Alert Service Bulletin No. 076

200F, 201F, 202F Fuel Pump Leak Inspection and Diaphragm Replacement

Figure 1 - 200F & 202F Identification

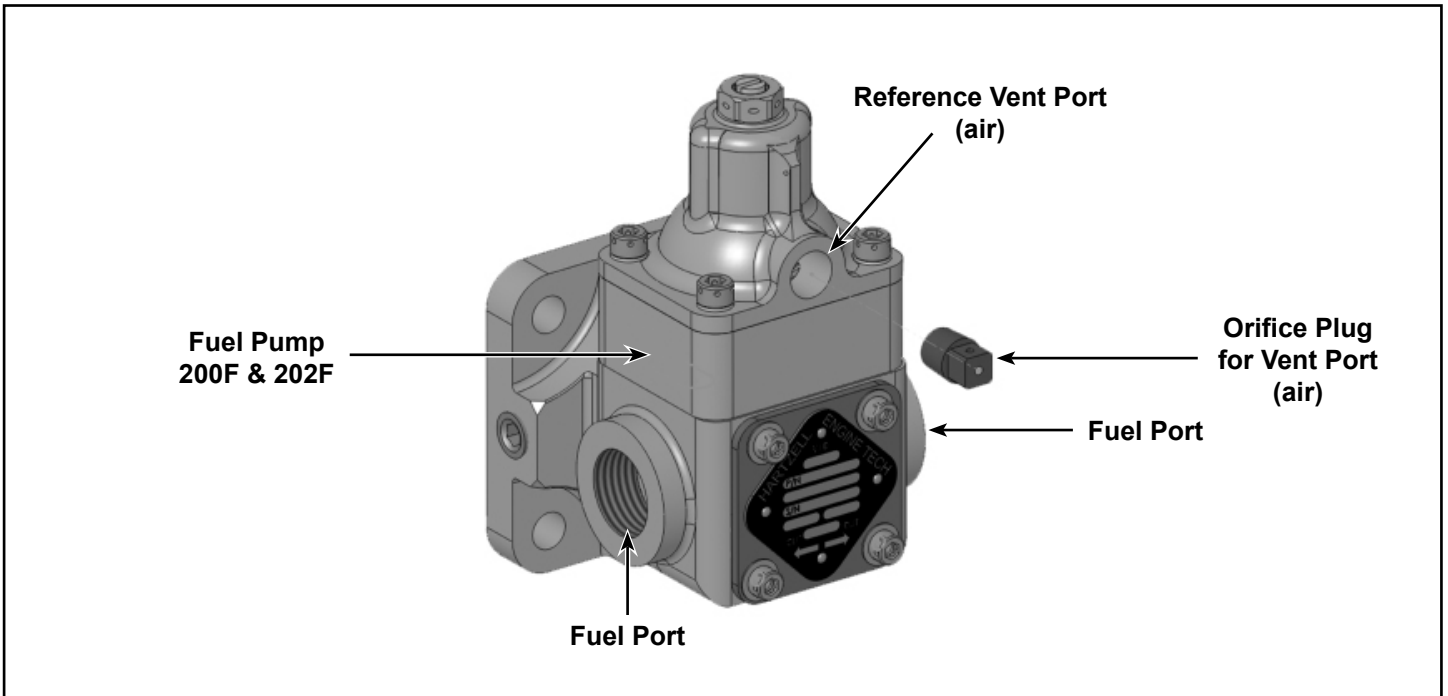
- (a) Inspection of the orifice plug requires only a visual inspection. Look around the plug and into the orifice for fuel or blue dye stains. Refer to Fig. 1 or Fig. 2.

Figure 4 - Typical Cooling Shroud Installation

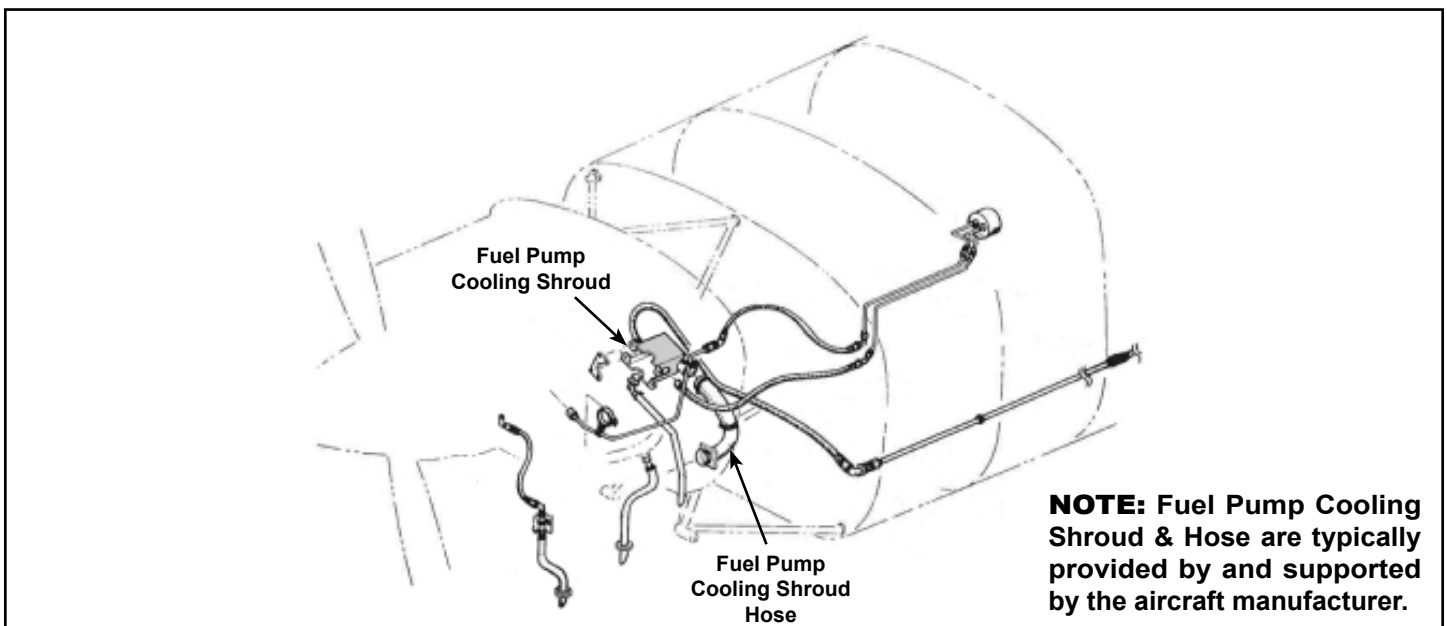
- (c) If removed, reinstall the fuel pump cooling shroud and air hose (if applicable) in accordance with the latest engine/airframe service instructions or maintenance manual and continue to 3.D.(1), Return to Service. Refer to Fig. 4.

Figure 5 - Typical HET 201F Fuel Pump Plumbed to Upper Deck Reference

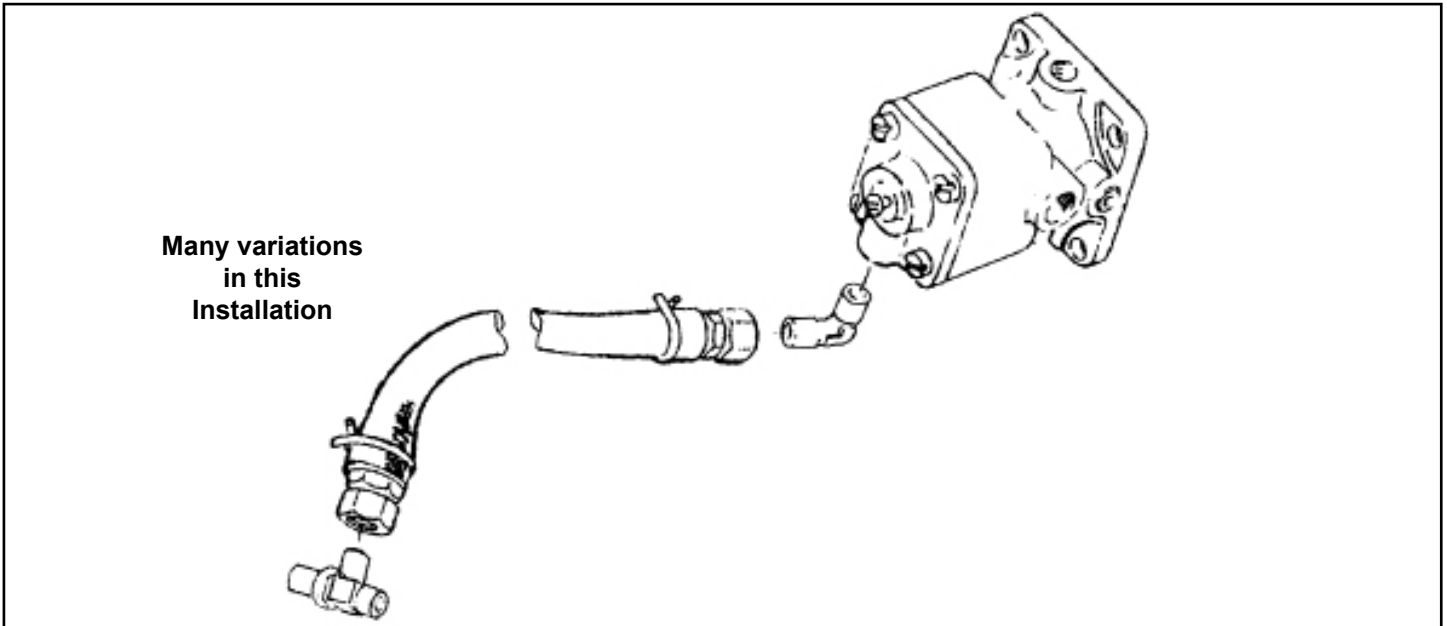
- (b) Inspection of the upper deck reference line requires that the line be disconnected and the inside of the fitting be inspected for fuel or blue dye stains. Refer to Fig. 5 and 6.

Figure 6 - Typical HET 201F Fuel Pump Turbocharger Reference Line Connection

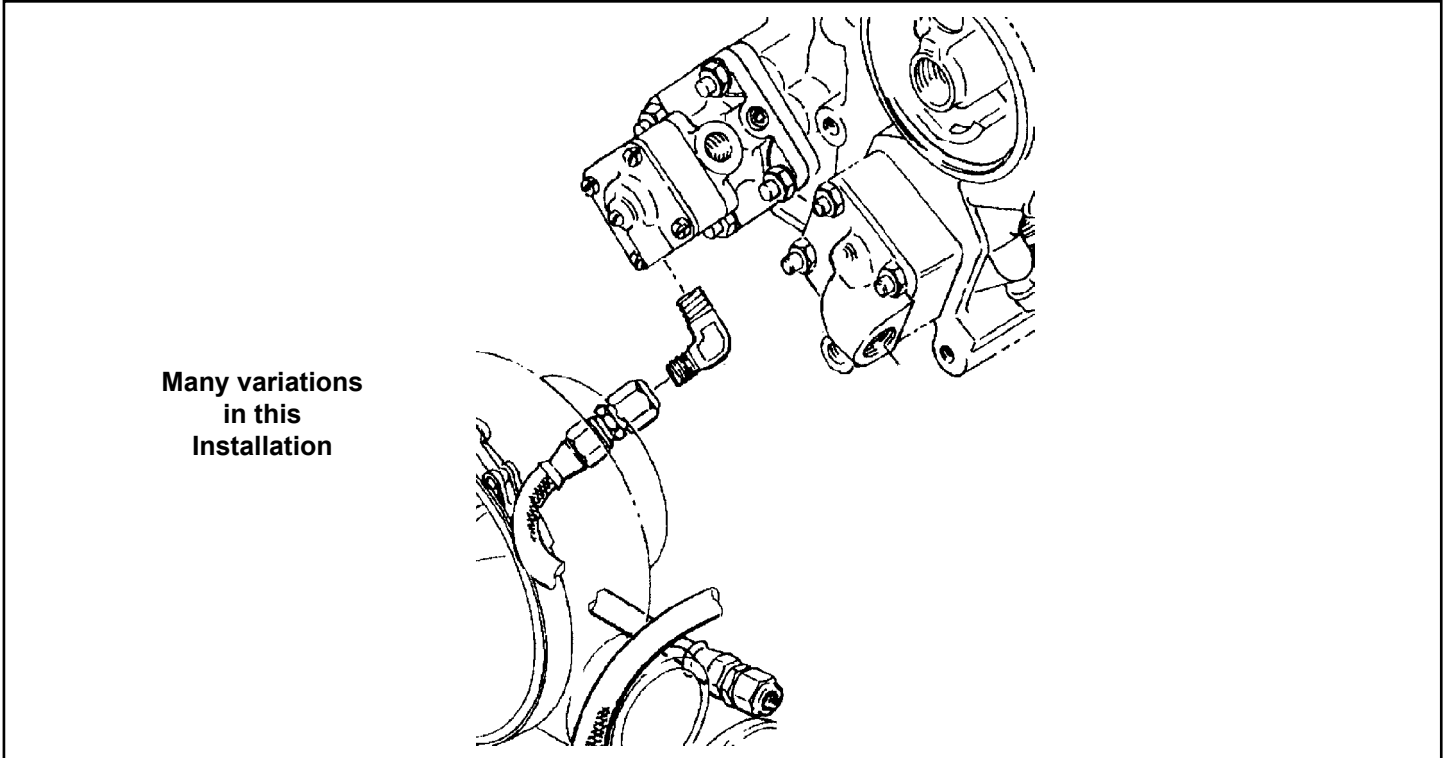
- (c) Inspection of the engine turbocharger reference line will require that the "B" nut be removed and the inside of the fitting be inspected for fuel or blue dye stains.
